Addendum (ADD) #02

Project:	20-602: Marshfield Early Childhood Center
Client:	Marshfield R-I School District
Date:	June 18, 2021

ADDENDUM 02

PROJECT: Marshfield Early Childhood Center

C501 MARSHFIELD ECC
LANDSCAPING PLAN

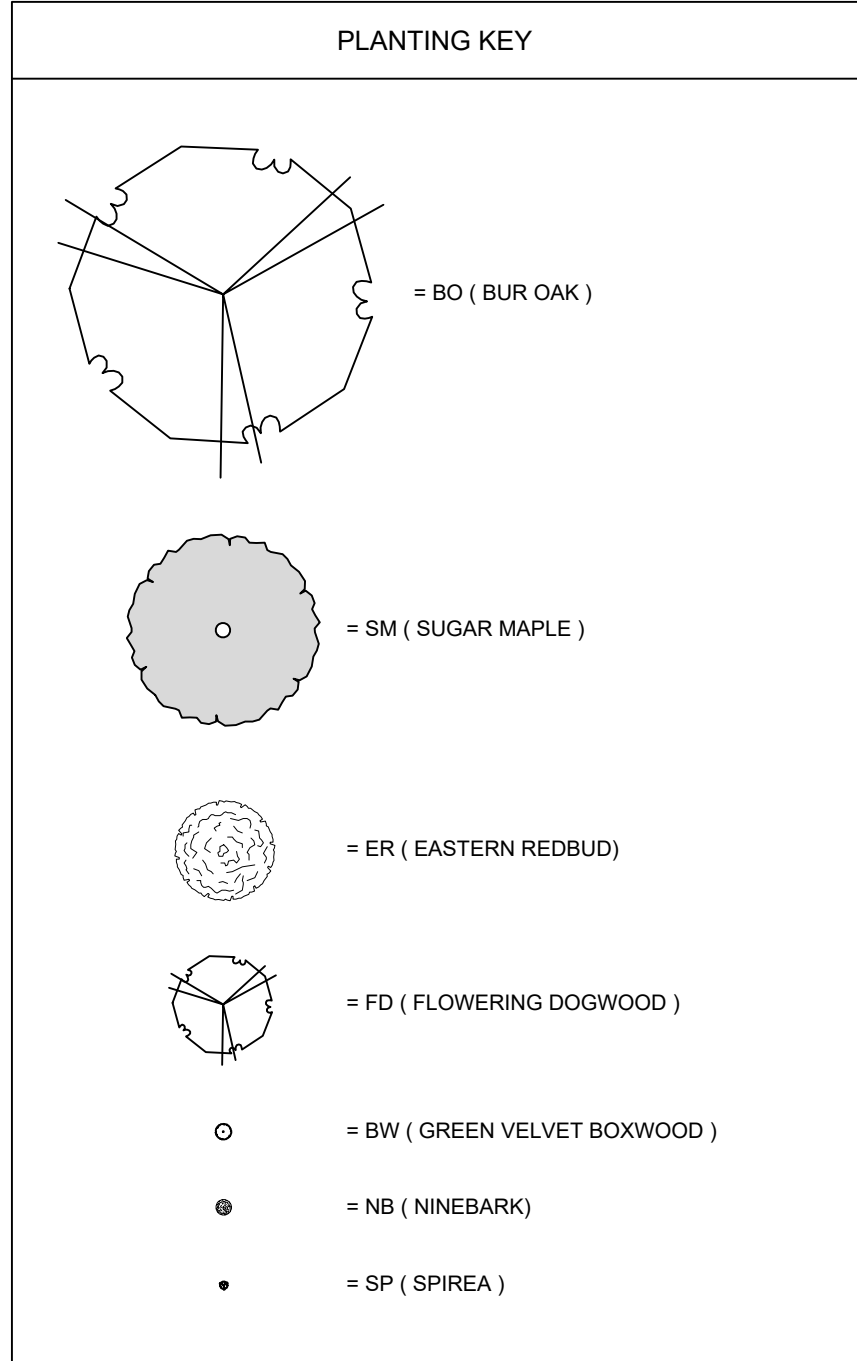
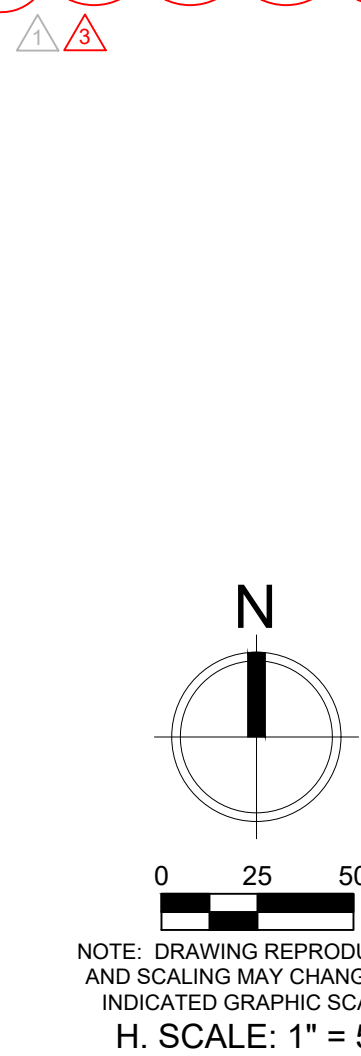
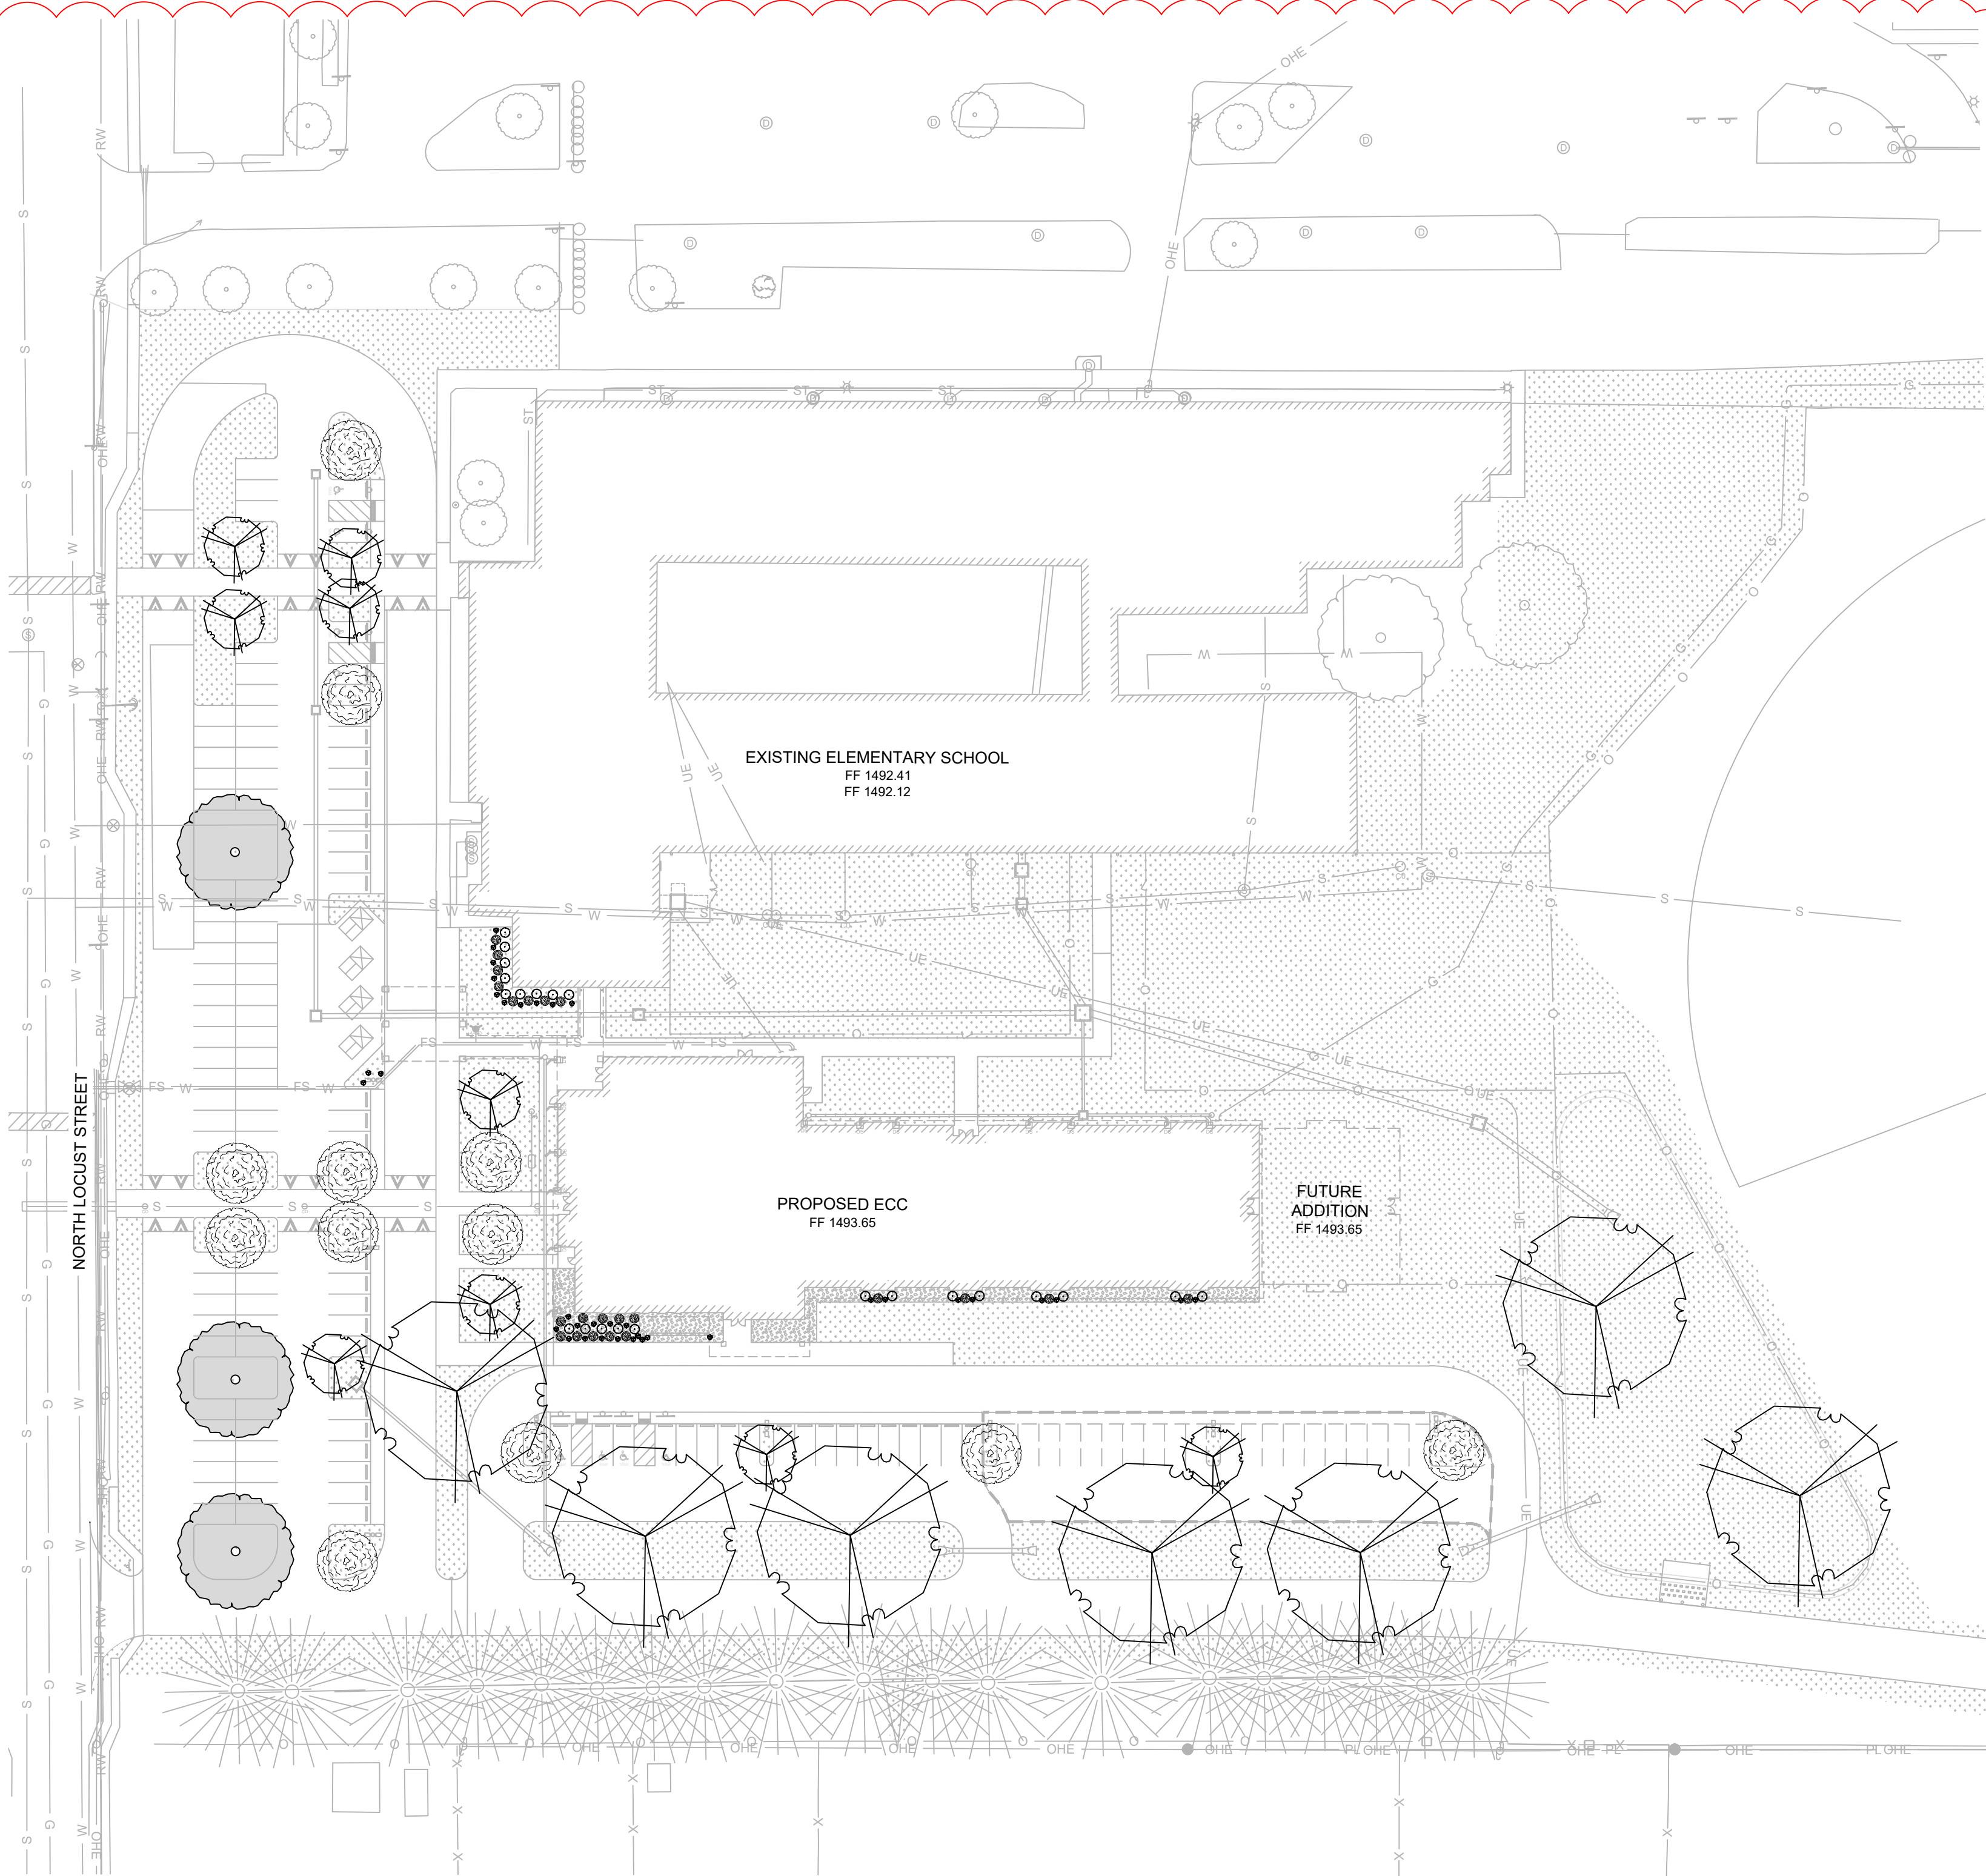
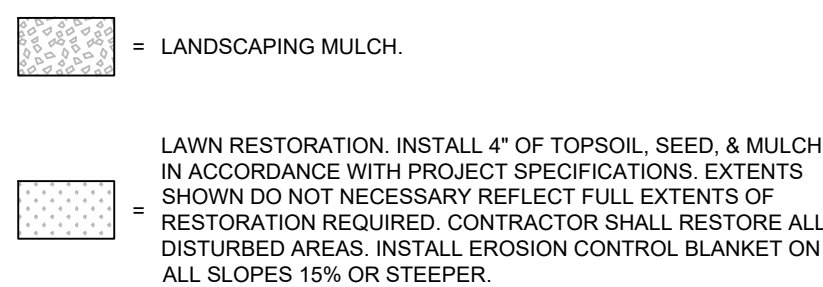
1. Sheet C501 was revised to reflect the Marshfield Planning & Zoning Committee comments, including the number of shrubs required, shrub locations, and plant species.
2. The Bioswale Typical Section Detail on Sheet C702 was revised to remove plants.

- THE OWNER IS RESPONSIBLE FOR FURNISHING AND INSTALLING PLANTS AS INDICATED ON THIS SHEET. AS DETERMINED BY THE MARSHFIELD PLANNING AND ZONING COMMITTEE, THE OWNER IS RESPONSIBLE FOR INSTALLING 40 SHRUBS DURING PHASE 1 AND 20 ADDITIONAL SHRUBS IN THE SUBSEQUENT TWO YEARS, FOR A TOTAL OF 60 SHRUBS.

TOTAL PLANTS REQUIRED: 50 TREES & 80 SHRUBS (PER P&Z VARIANCE)

A1-0 MARSHFIELD EARLY CHILDHOOD CENTER
FLOOR PLAN - AREA A
PROJECT NUMBER: 20-602
DATE: 2021.06.09
PROJECT ARCHITECT: CS, KMW
DRAWN BY: BEE
CHECKED BY: KMW, FY

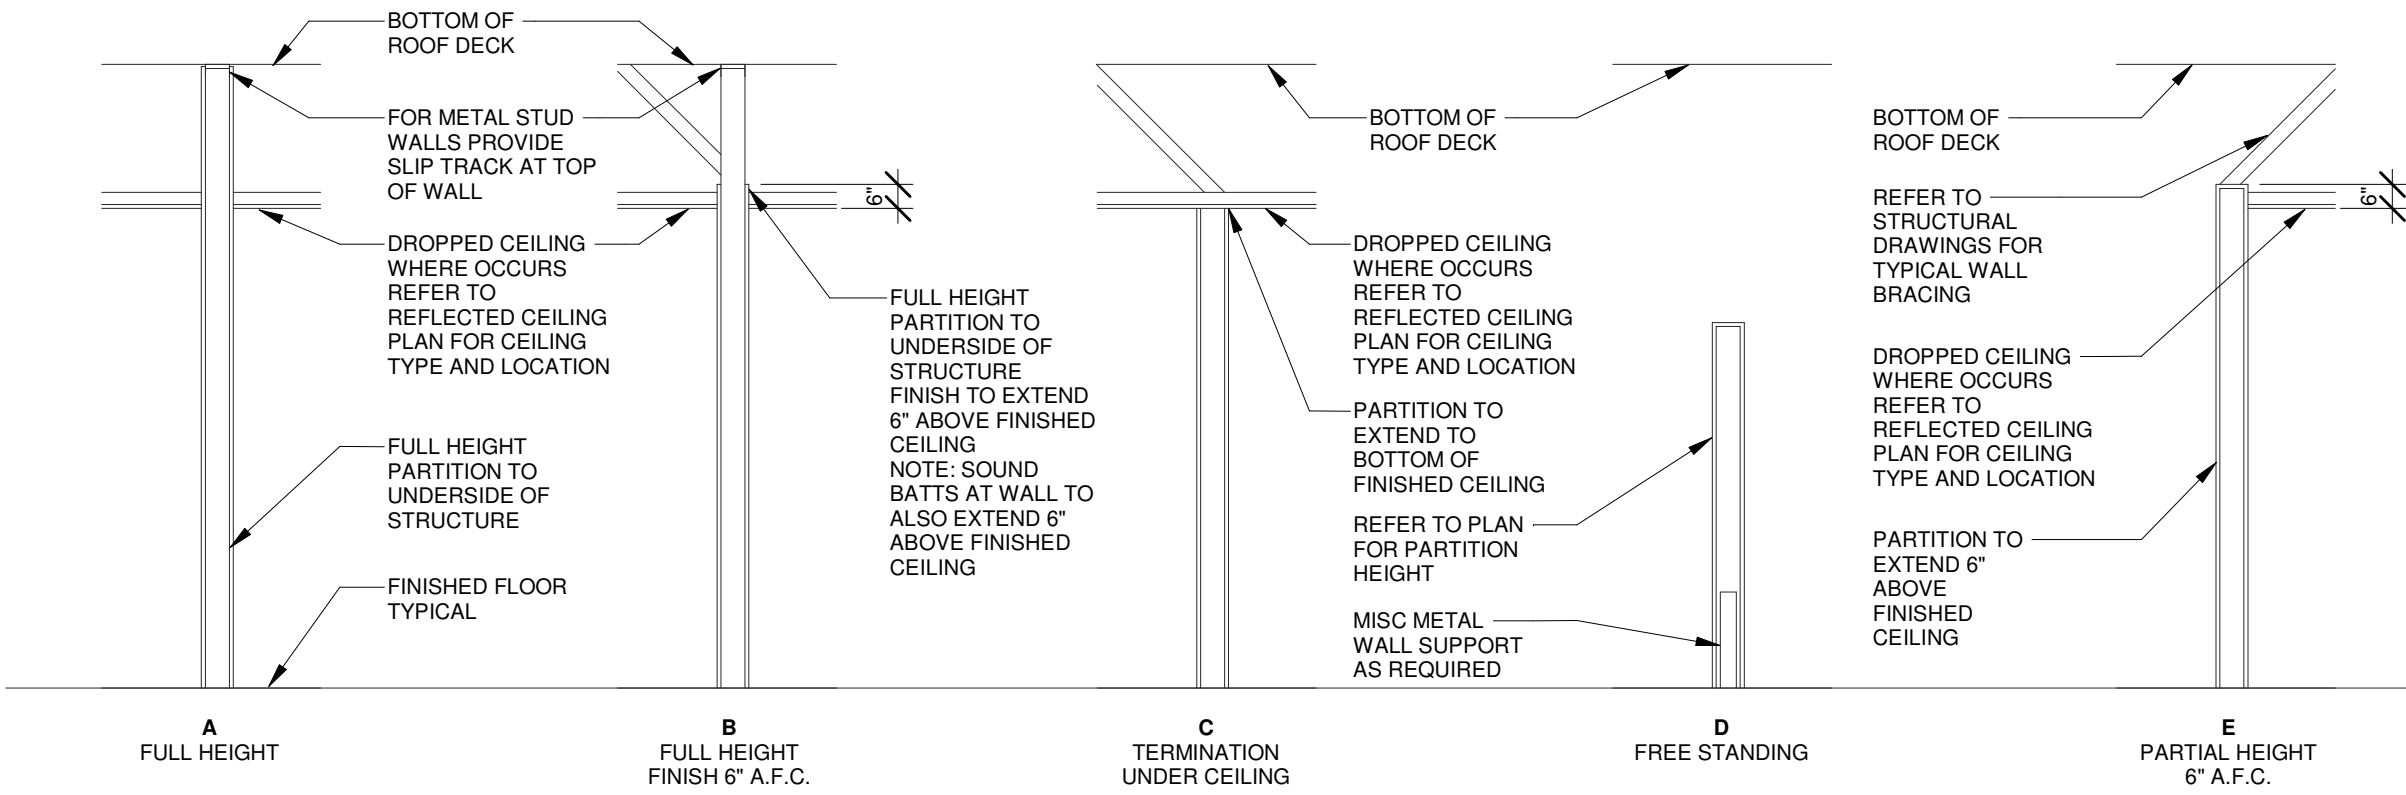
- 7. *Sheet A1-0 – Floor Plan - Area A:*
 - a. Clarify, Detail 1
 - i. There are upper cabinets in Room 061 per detail 3/A7-5.
 - b. Revise, Detail 1
 - i. All partitions classified as 'C' should be 'B'.

AREA A: FINISH PLAN

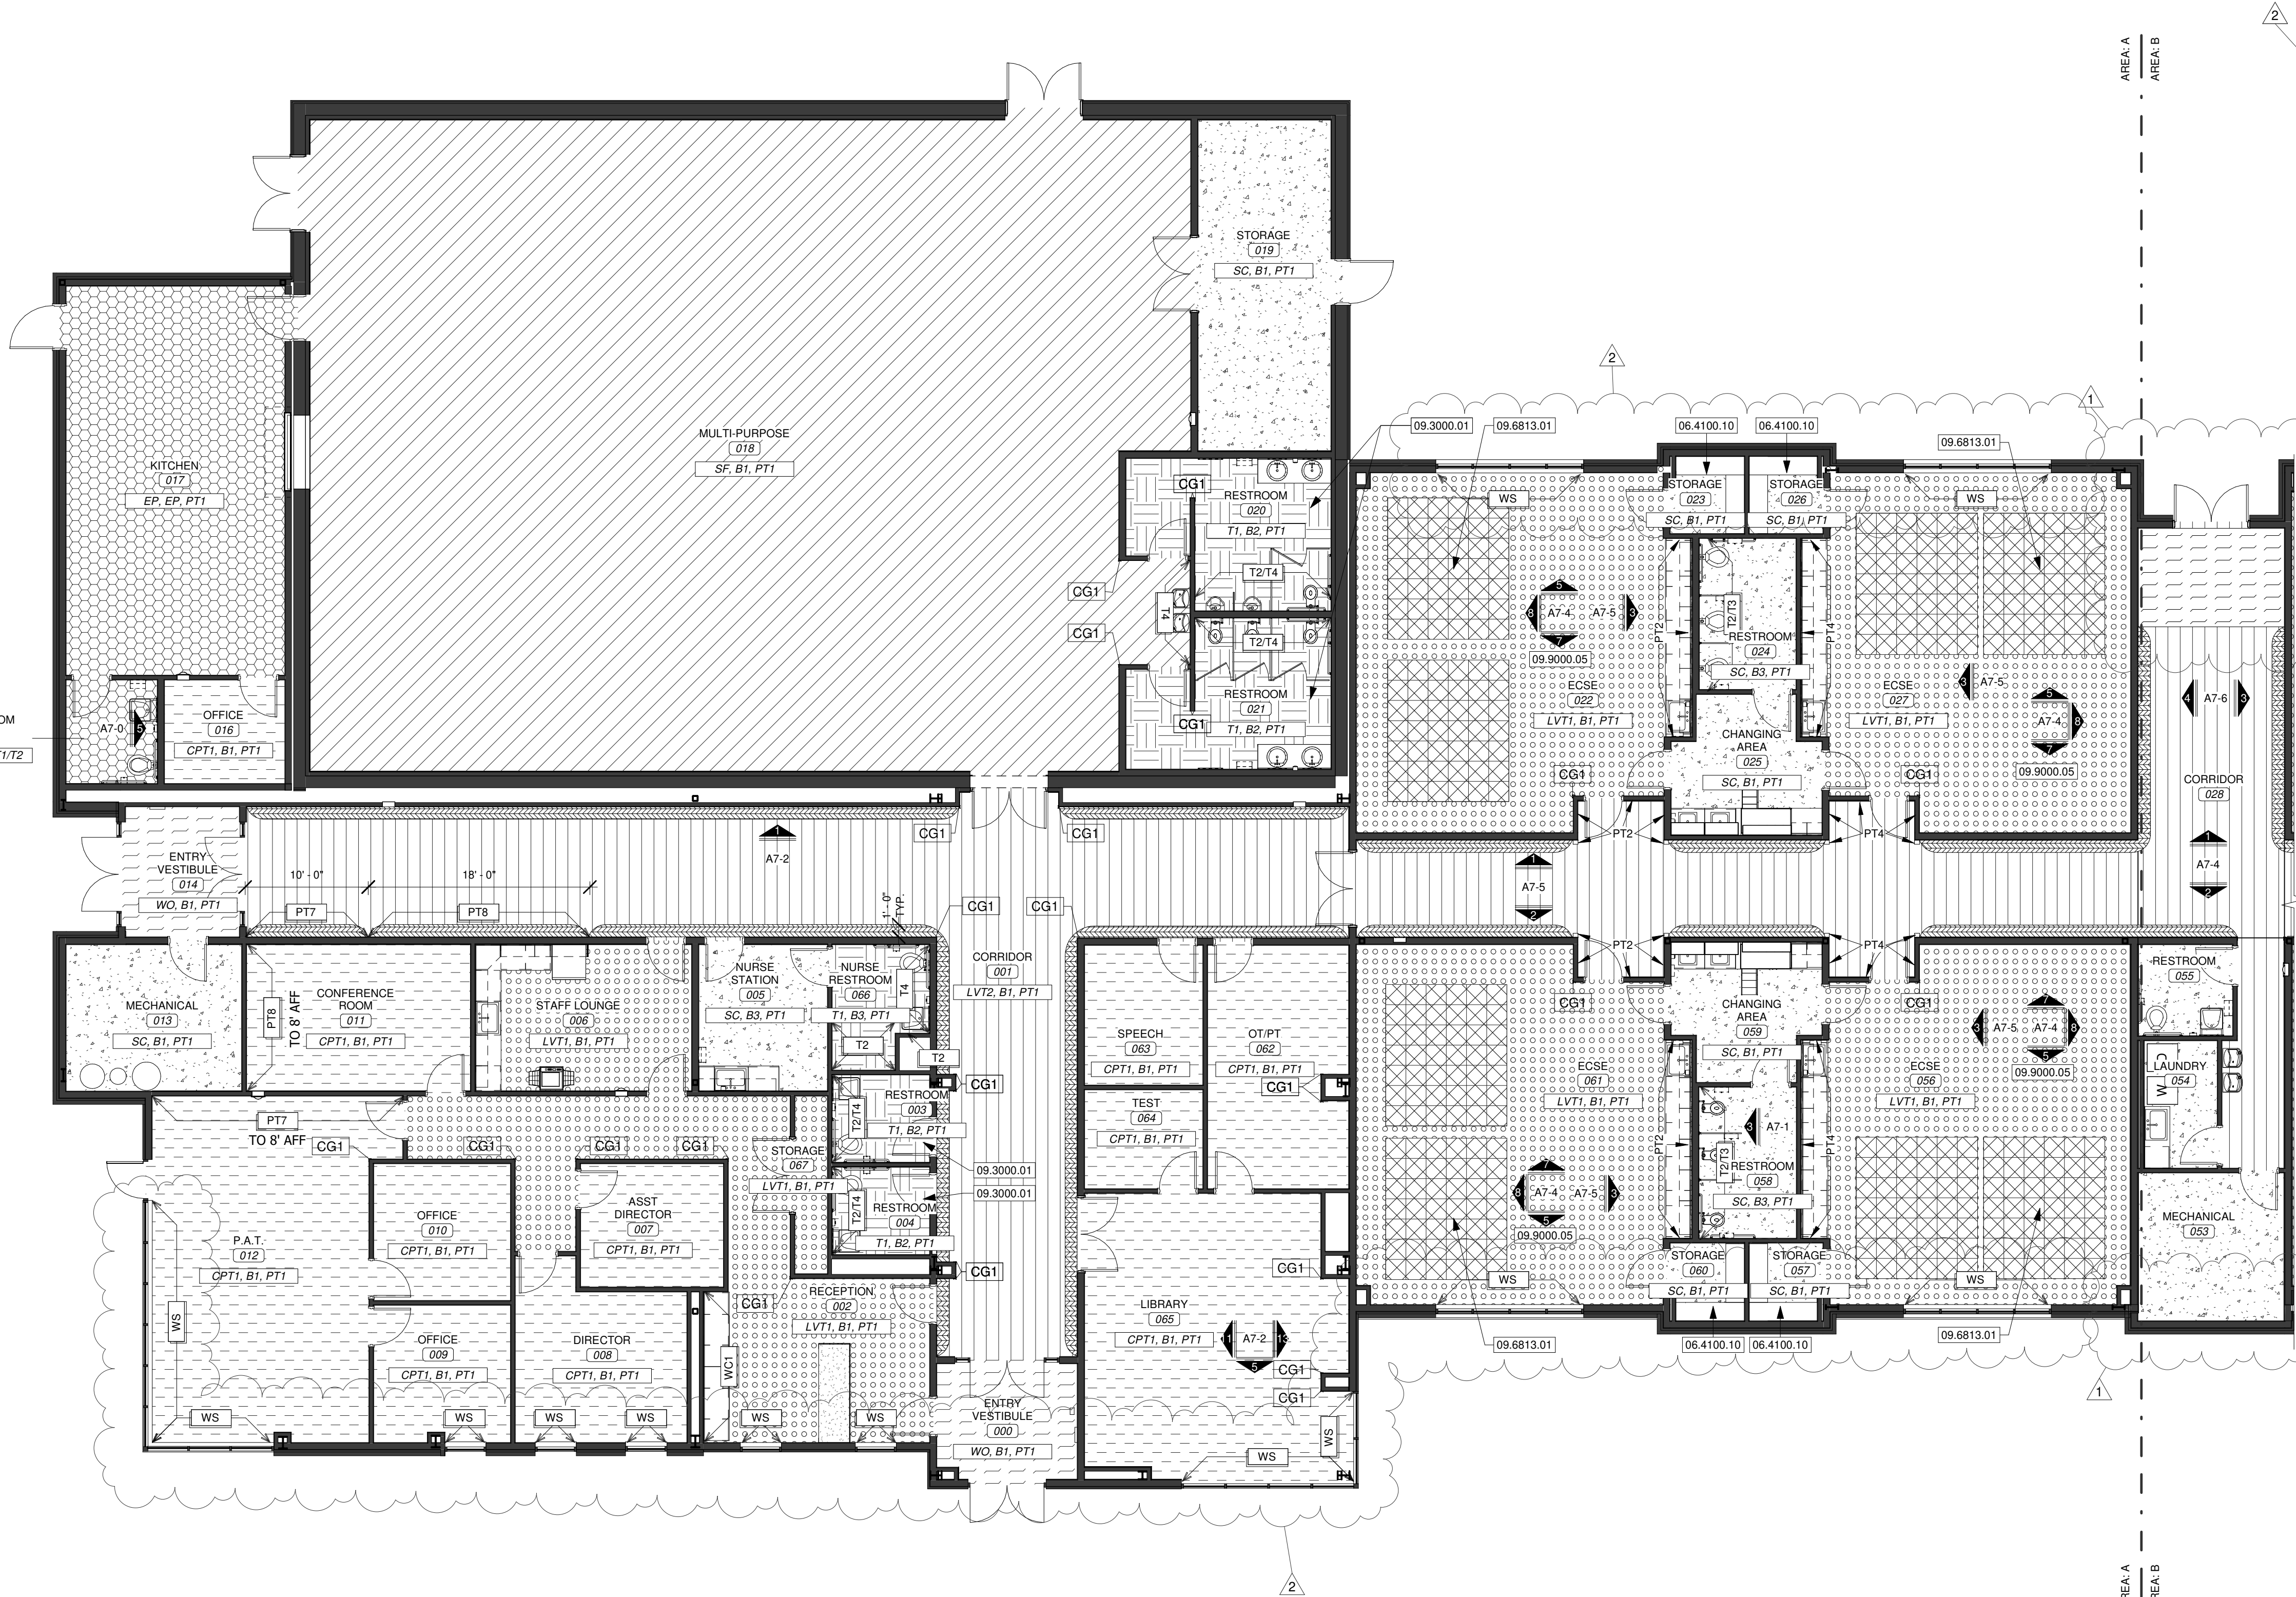
- i. Signage depth removed from plan. Depth to be standard manufacturer's depth.
- 10. *Sheet A9-0 – Finish Plan – Area A:*
 - a. Revise, Finish Plan Legend

- i. SC - Sealed Concrete was added.
 - ii. CG1 – Stainless Steel Corner Guards was added.
 - iii. WS – Window Shades was added.
 - b. Revise, Detail 1
 - i. WS locations were added.
